Access Compliance Report

Public Rights-of-Way

(Curb Ramps)

Intersection ID: 46182	Main Street: SEVEN_OAKS_DR	Cross Street: GLOXINIA_RD	Location:	N
ADA ID: 5C5DCC62C71E	Ramp Type: PerpDiag	Initial Pass/Fail: Fail	Overall Compliance: No	Severity Score: 8.75

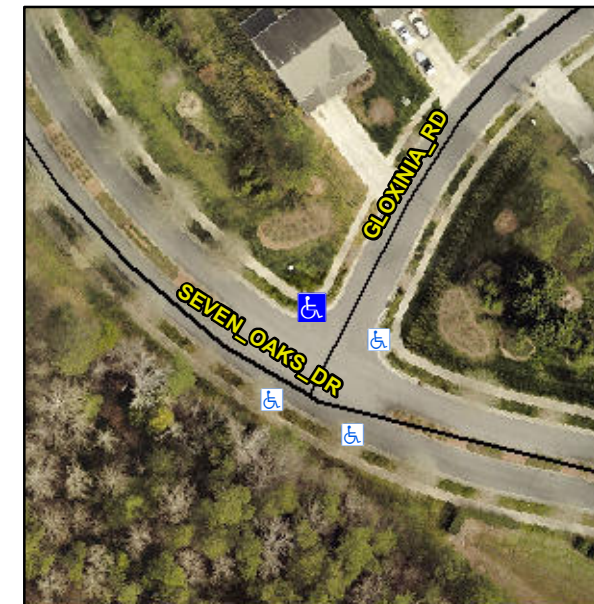
Not Found, R304.5.1

Compliance	Description	Data	Compliance	Description	Data
N/A	Ramp Length (in)	64.0	Yes	Ramp Slope (%)	7.3
No	Ramp Width (in)	47.5	Yes	Ramp XSlope (%)	0.9
N/A	Flare Type LT	N/A	N/A	Flare Type RT	N/A
N/A	Flare Slope LT (%)	N/A	N/A	Flare Slope RT (%)	N/A
N/A	Flare Traversable LT?	N/A	N/A	Flare Traversable RT?	N/A
N/A	Landing Length (in)	N/A	N/A	DWS Provided?	N/A
N/A	Landing Width (in)	N/A	N/A	DWS Contrast?	N/A
N/A	Landing Slope (%)	N/A	N/A	DWS Length (in)	N/A
N/A	Landing X Slope (%)	N/A	N/A	DWS Full Width?	N/A
N/A	Landing Curb? (Y/N)	N/A	N/A	DWS Offset (in)	N/A
N/A	Shared Landing?	N/A			
N/A	Gutter Ponding?	N/A	N/A	Gutter Slope (%)	N/A
N/A	Gutter Lip Ht (in)	N/A	N/A	Gutter X Slope (%)	N/A
N/A	Painted X Walk1?	No	N/A	Painted X Walk2?	No
	X Walk 1 Direction	To SW		X Walk 2 Direction	To SE
N/A	X Walk 1 Width (in)	N/A	N/A	X Walk 2 Width (in)	N/A
	X Walk 1 Slope (%)	0.5		X Walk 2 Slope (%)	0.5
	X Walk 1 X Slope (%)	0.9		X Walk 2 X Slope (%)	2.6

Remove & Replace Curb Ramp With Two New Directional Ramps or Equivalent.
